Addendum to EIR
University Villages – Village Three North and a Portion of Village Four

PROJECT NAME: University Villages EIR 13-01; SCH No 2013071077 – Village Three North and a Portion of Village Four

DATE: September 19, 2016

FIGURE 4
Proposed Project Site Utilization Plan

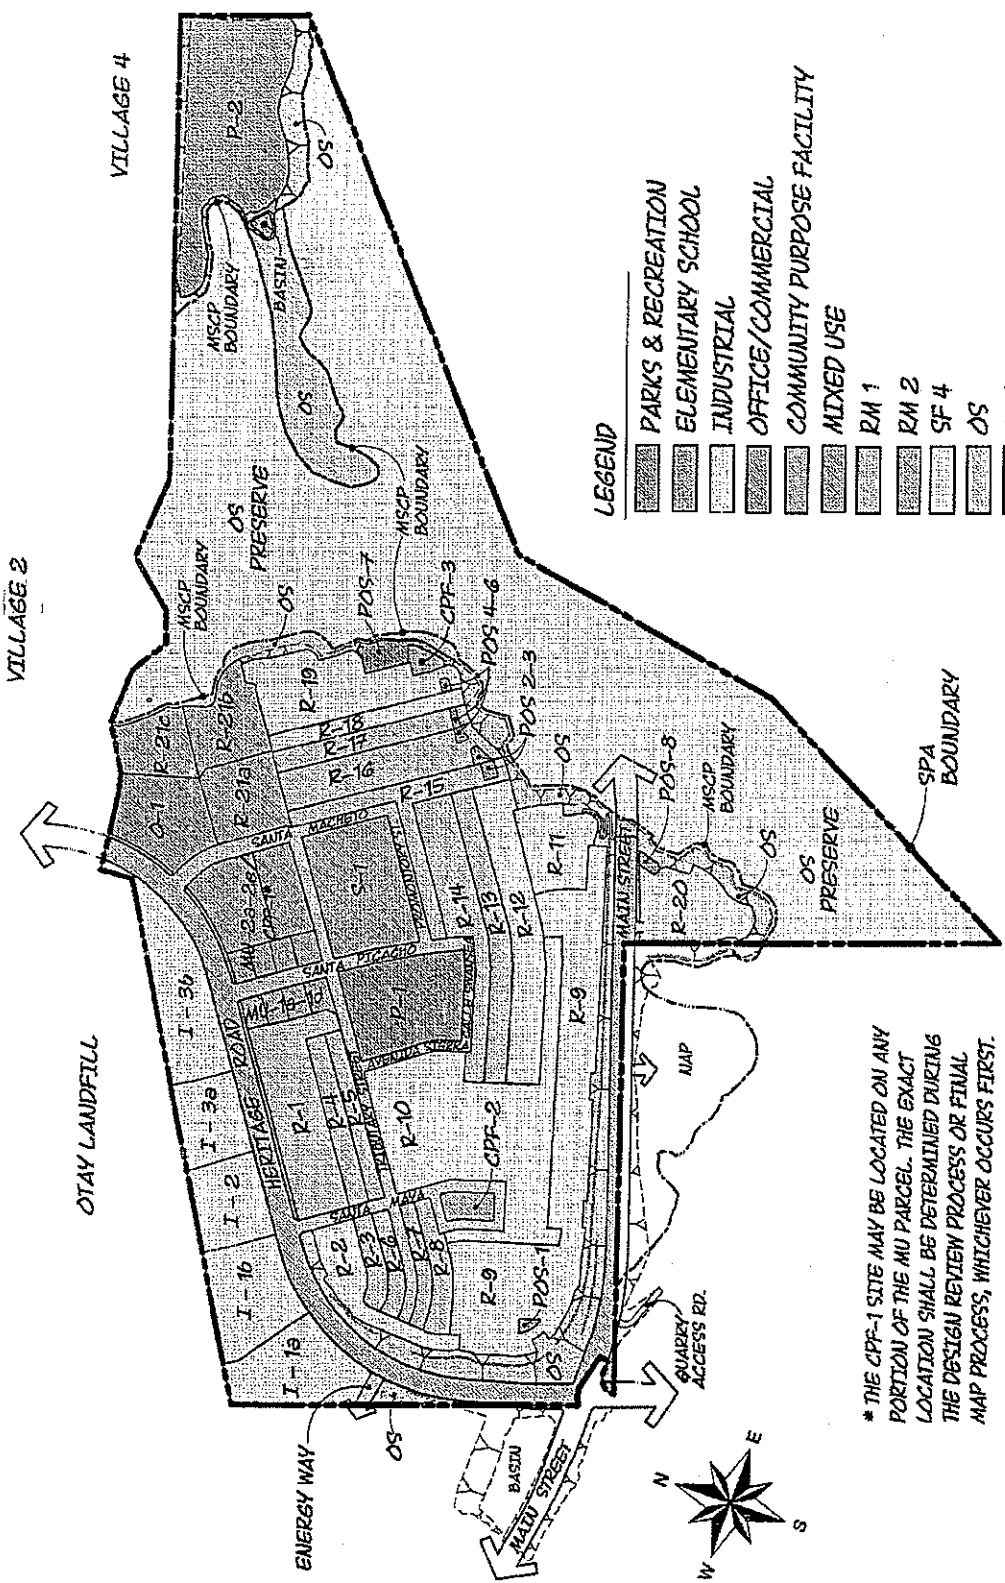
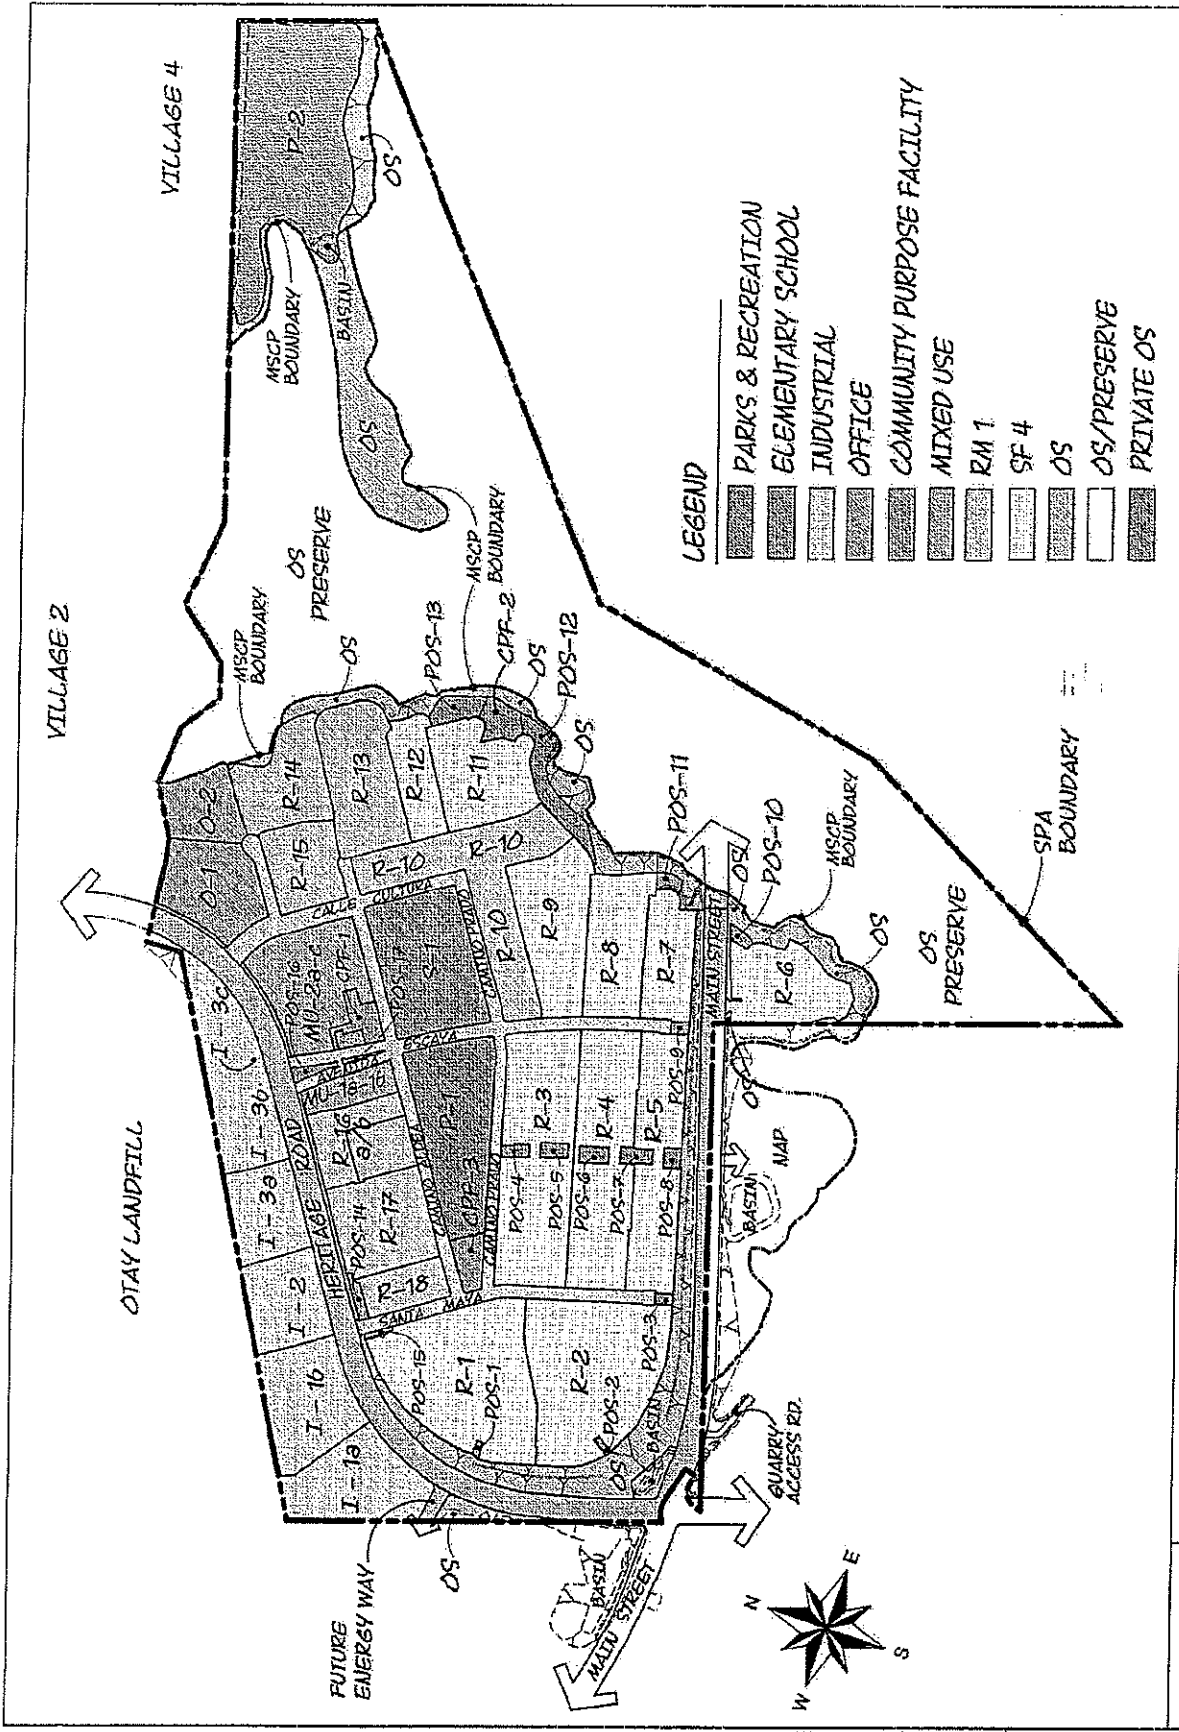
The approved land use plan for Village Three North and a Portion of Village Four would allow for the construction of 1,002 single-family units, 515 multiple-family units, and 80 mixed-use units; 8.3 acres for a school; 29.3 acres of industrial land use; 4.3 acres of Community-Purpose Facilities (CPF); 8.3 acres of office; 25.9 acres of parkland; and 34.8 acres of open space (Figure 3). There would be no proposed changes to the Portion of Village Four. The proposed modifications to the approved project are as follows (see Figure 4):

- Maintain 1,002 single-family and 595 multiple-family, 1,597 dwelling units in total, as previously approved within Village Three North.
- Update the SPA Site Utilization Plan and Table to reflect the revised land use plan, internal streets, neighborhood boundaries, and unit allocation by neighborhood.
- Revise the single-family lotting pattern to include the following new lot sizes/products:
 - 50 × 90 feet
 - 55 × 90 feet
 - Detached courtyard
- Establish a multiple-family neighborhood (R-16) adjacent to the Mixed Use (MU)-1 parcel.

- Provide a north–south meandering paseo, designated Private Open Space (POS) 4-8, through the single-family neighborhoods, providing a strong pedestrian connection to the elementary school, public neighborhood park, and village core

- Assign 198 multiple-family units to the MU-2 parcel for a total of 278 multiple-family units within the MU-1 and MU-2 parcels
- Reconfigure the P-1 Neighborhood Park

- Relocate the Community Purpose Facility (CPF)-3 site adjacent to the P-1 Park
- Modify the central entry street (Avenida Escaya) through the MU area to create a strong sense of arrival and activity within the corridor, while providing a grand landscaped median (“Village Green”) and enhancing the viability of the retail and commercial spaces fronting the street.

- Realign the residential street at the southeastern corner of Village Three North and designate a Private Open Space (POS) at the project perimeter
- Provide an additional 3 2-acre Office (O) parcel (O-2) east of the O-1 site

- Reconfigure the Village Three North Water Quality/Hydromodification basins to include three basins: one on-site 0.6-acre basin at the southwest corner of Village Three North and two off-site basins, including a 3.9-acre basin north of Main Street and west of Heritage Road (former Takashima property) and a 1.75-acre Water Quality/Hydromodification basin within Village Three South to the south of Main Street (Flat Rock property)

- Eliminate two Industrial Street cul-de-sacs within the Industrial area north of Heritage Road, provide driveway entries to the Industrial area and update the Industrial acreage
